**To:** Samantha Crowder (Land Perspectives LLC)  
**From:** Christopher LaRue, Senior Planner  
**Date:** March 20, 2020  
**Re:** PP-001137-2020: Collier Hill 4G Preliminary Plat Application  
**cc:** Deborah Bachelder, Joe Smith, David Pasic, Darren Champion

### **Colliers Hill Filing 4G Preliminary Construction Plans**

Sheet L-23

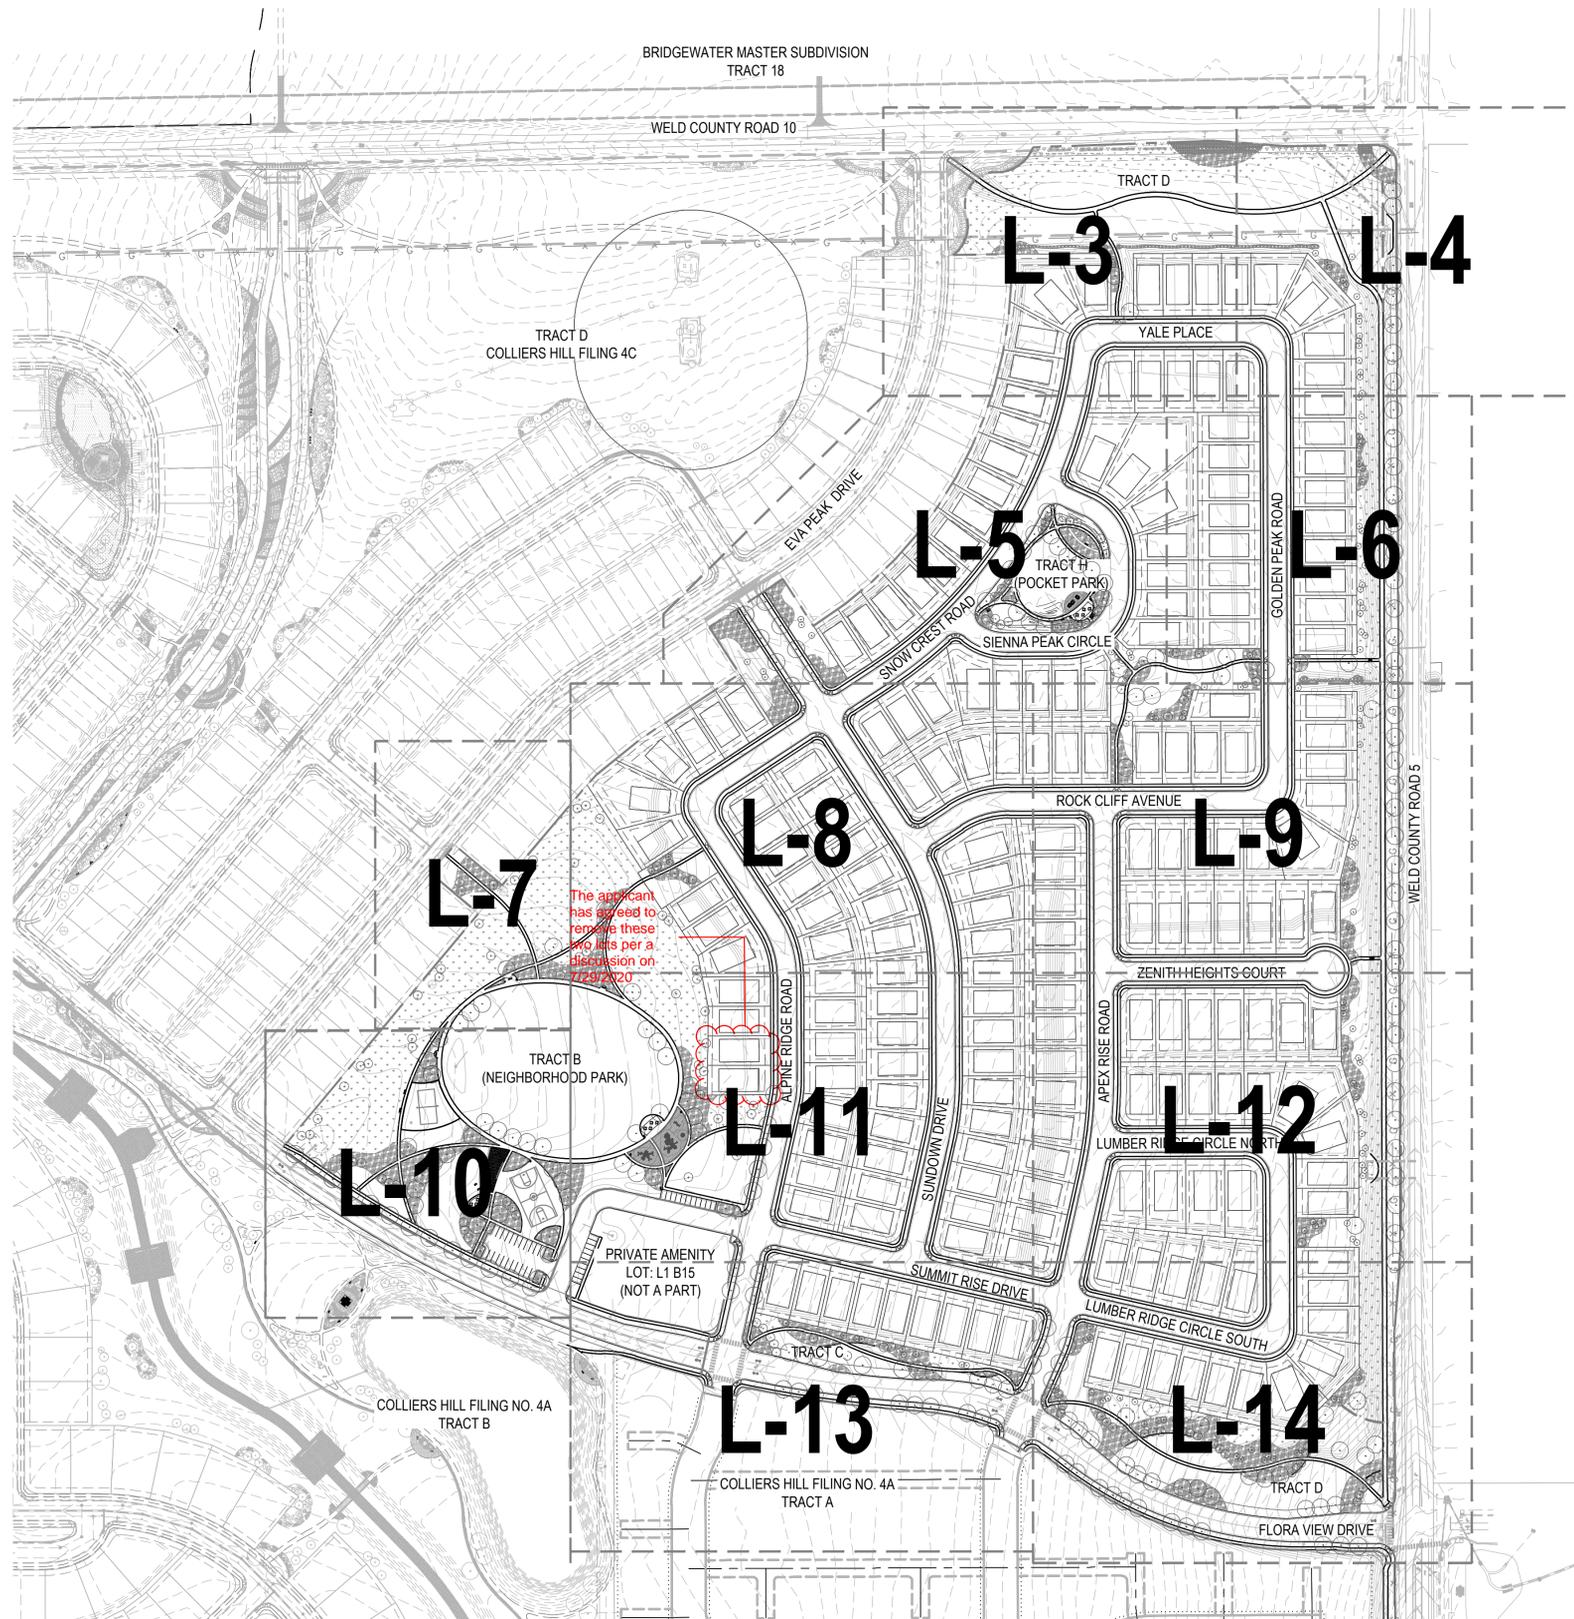
- 1) It looks like the internal loop trail of the neighborhood park is not reflected as an 8' concrete trail.

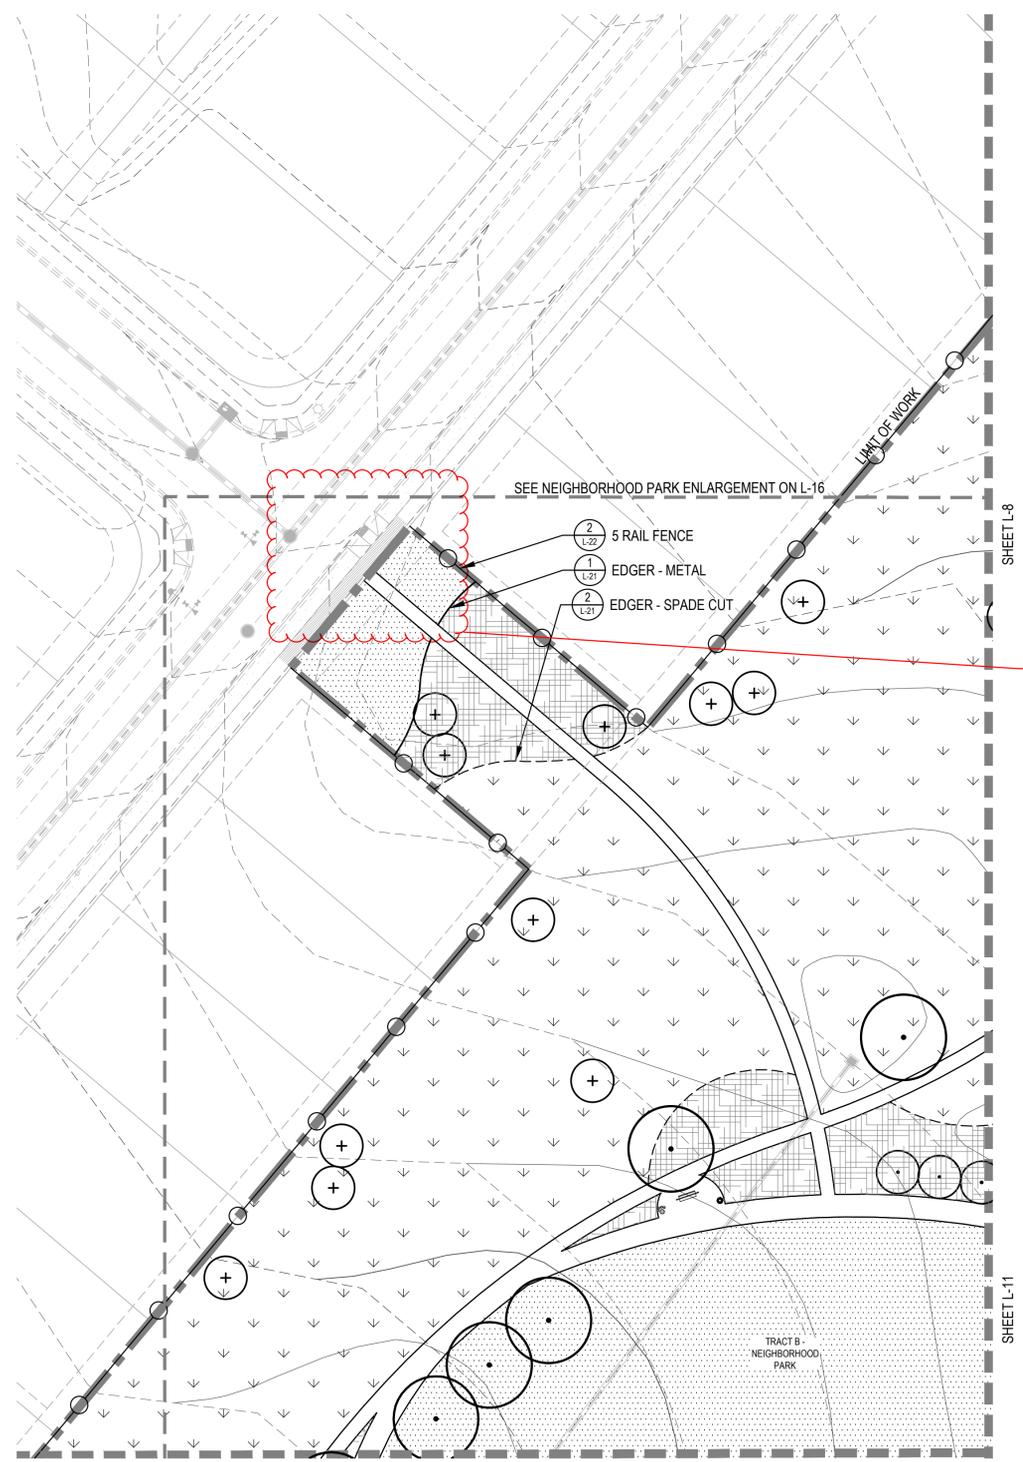
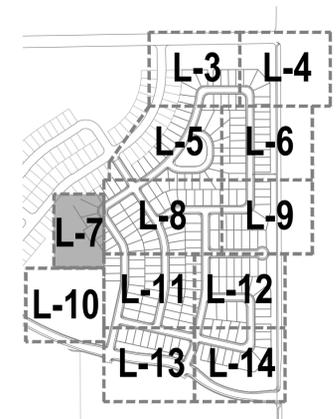
Please ensure that the new connector trail aligns with the existing street access ramp.
